# Access Compliance Report Public Rights-of-Way (Curb Ramps)

| Main Street: BENJAMIN_DR |                              | Cross Street: BENJAMIN_DR |                        | Location:       | S  |
| ADA ID: RPRK211020160246 | Ramp Type: Type 4 - Parallel | Initial Pass/Fail: Pass   | Overall Compliance: No | Severity Score: | 40 |

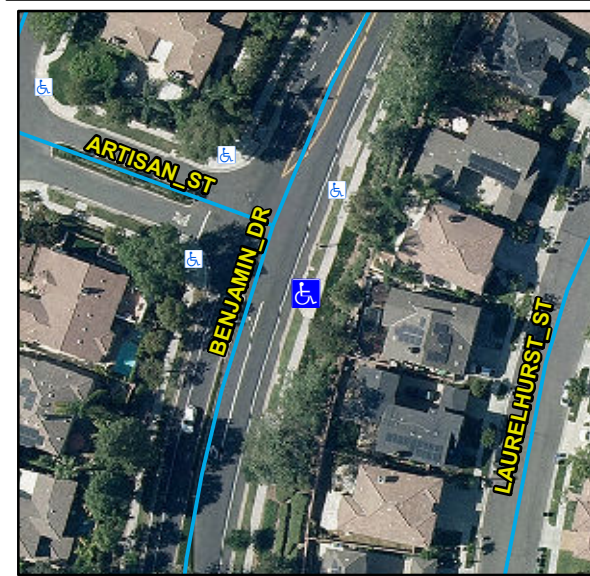
R204.3, R304.5.3, R304.2.1, R304.2.2-Perp, R304.3.2-Para, R305, R304.5.4, STD 1115

| Compliance | Description                   | Data       | Compliance | Description                   | Data |
|------------|-------------------------------|------------|------------|-------------------------------|------|
| No         | Ramp Cross Slope LT (%)       | 3.7        | No         | Ramp Cross Slope RT (%)       | 5.5  |
| No         | Landing Width (in)            | N/A        | N/A        | DWS Length (in)               | N/A  |
| No         | Landing Run Slope (%)         | N/A        | N/A        | DWS Full Width                | N/A  |
| No         | Landing Cross Slope (%)       | N/A        |            | DWS Offset Type               | N/A  |
| No         | Gutter Run Slope (%)          | 7.4        |            | Road Cross Slope (%)          | N/A  |

Remove & Replace Entire Ramp. Remove & Replace Gutter.
